**101 Military Road, Dover Heights - Significant alterations and additions to detached dwelling including first floor additions, double garage, roof terrace and swimming pool (DA 576/2009).**

Report dated 8 July, 2010 from the Development & Building Unit.

<b>Development Assessment Report of Dwelling</b>	
Development Application No.	<b>DA 576/2009</b>
Address	<b>101 Military Road, Dover Heights</b>
Lodgement Date	<b>9 November 2009, amended 30 April 2010</b>
Proposal	<b>Significant alterations and additions to detached dwelling including first floor additions, double garage, roof terrace and swimming pool</b>
Zoning and relevant controls	<ul style="list-style-type: none"> <li>• Residential 2(a) according to Waverley LEP 1996</li> <li>• Waverley Development Control Plan (WDCP) 2006</li> </ul>
Owner	<b>Ms G Panselinos</b>
Applicant	<b>Ms G Panselinos</b>
Submissions	<b>Original application - 4 submissions; Amended application -4 submissions</b>
Issues	<b>Height, FSR, view loss, elevated deck / roof terrace</b>
Recommendation	<b>That the application be APPROVED</b>

PROPOSED FIRST FLOOR PLAN  
 SCALE 1:100

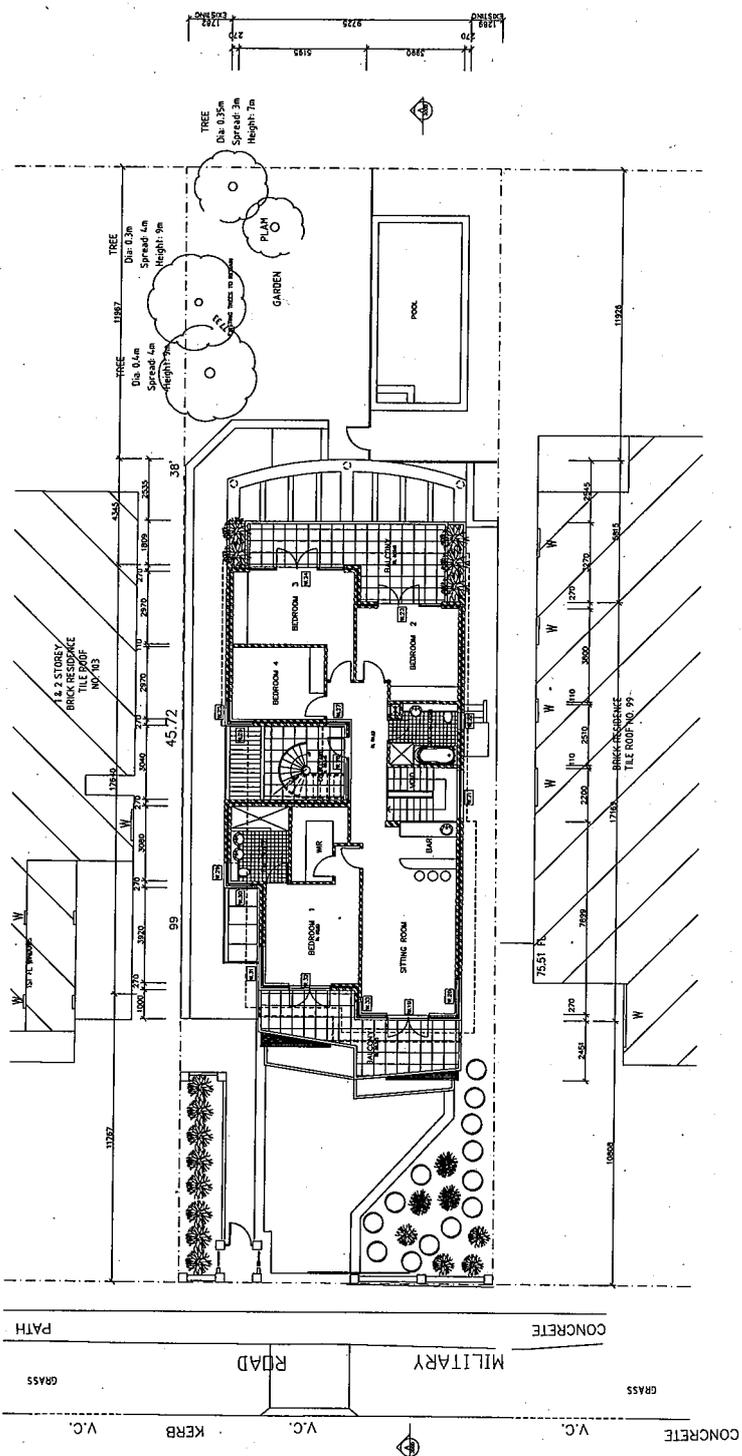
The rear first floor balconies are accessed from bedrooms, considered low-use activity rooms, providing planters to either side. Whilst over the allowable size, it primarily overlooks the back yard area of the site. However, to further mitigate privacy impacts, it is recommended privacy screening be installed along either side of the balcony (on the outer side to the planting), considered to adequately address privacy impacts to adjoining properties in this instance.

The development proposes balconies at the front of the building (ground and first floor levels), predominantly overlooking the street, and a single balcony at the rear adjoining bedrooms with planters to either side. These balconies to the rear, adjoining bedrooms are considered relatively low use rooms and as such are not considered to result in an unreasonable privacy impacts to the adjoining properties. This balcony predominantly provides an outlook over the rear yard and pool area, whereby larger outdoor areas accessed from public areas of the dwelling (ie living / dining areas) are instead provided elsewhere on-site at lower levels or to the front of dwelling where impact is less. Furthermore, as previously additional privacy measures in the form of privacy screening is recommended to either side of this balcony to further mitigate privacy impacts, considered reasonable.

- (a) Privacy screening to a height of 1800mm shall be installed along the northern and southern side of the first floor rear balcony (on the outer side to the planters).
- (b) Balustrading to roof deck is to be transparent, to allow views to be maintained to adjoining properties.
- (c) The roofing material used shall be of low reflectivity.
- (d) Privacy screening (eg louvre screening) shall be installed on the entire northern side of the stairwell courtyard (first floor level) to a height of 2100mm.
- (e) The development shall be limited to a height of R.L 84.23 as measured to the top of the balustrade of the roof terrace.
- (f) No approval is expressed or implied for louvers to the roof section of the eastern elevation and should be deleted from the plan.

PROPOSED ROOF PLAN  
 SCALE 1:100

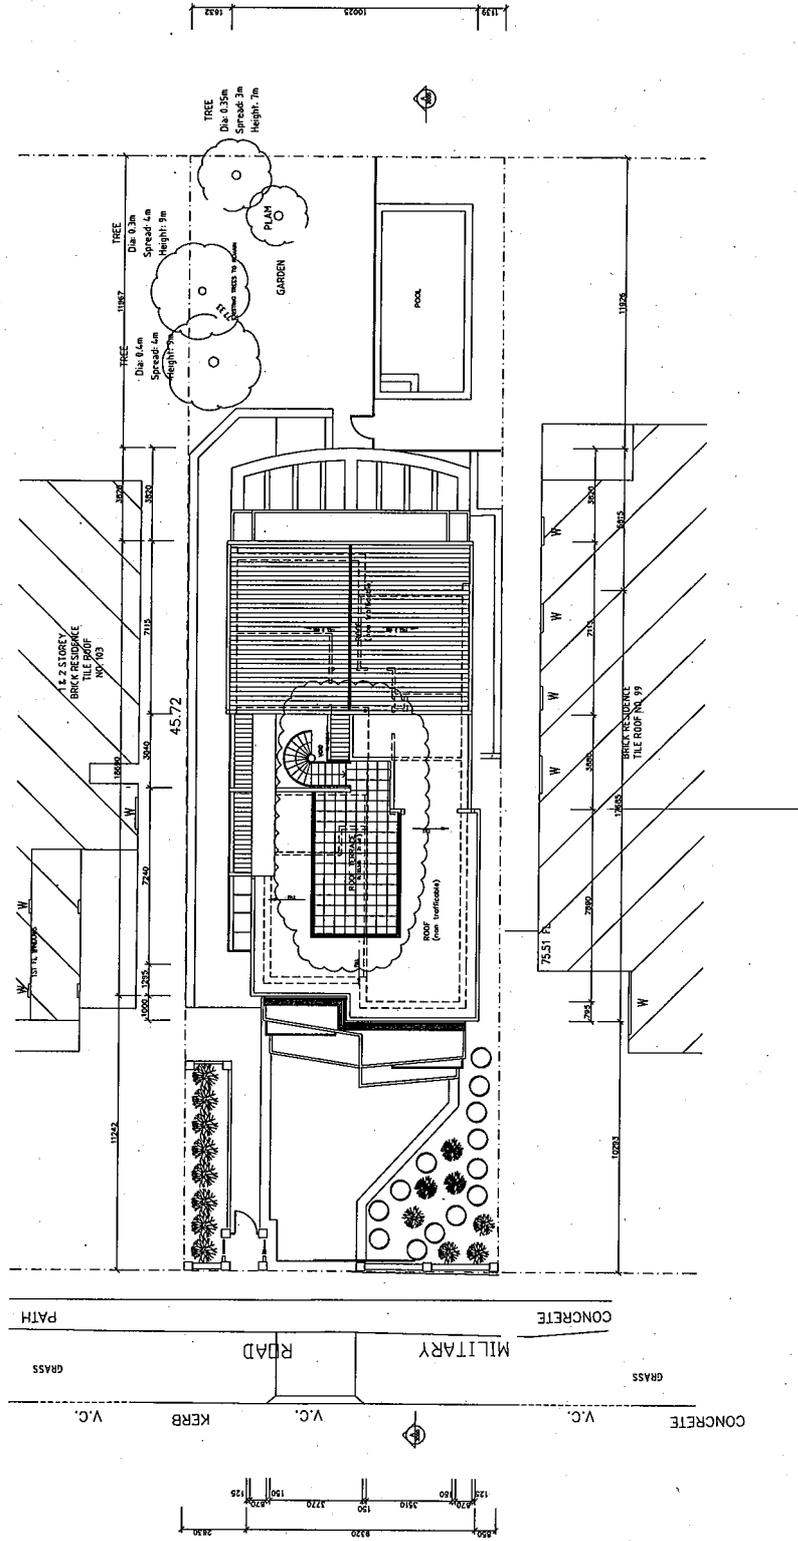
As outlined previously, the proposed roof terrace is not considered to result in any unreasonable overlooking of the adjoining properties, but rather looks out over adjoining roofs. Additionally, there are various roof terraces of a similar scale, size and design evident in the vicinity. The proposed roof terrace being centrally located in the middle of the roof is considered acceptable and will incorporate clear glazing to the balustrades to maintain views to properties at the rear.

In this regard, given the well considered design of the roof terrace which successfully mitigates the impacts generally associated with roof terraces, and the prevalence of roof terraces within the immediate vicinity, the proposed roof terrace is considered acceptable. However, to further mitigate privacy issues of the external stairwell providing access to the roof terrace, it is recommended screening (eg louvre screening) be installed on the entire northern side of the stairwell courtyard to a height of 2100mm.
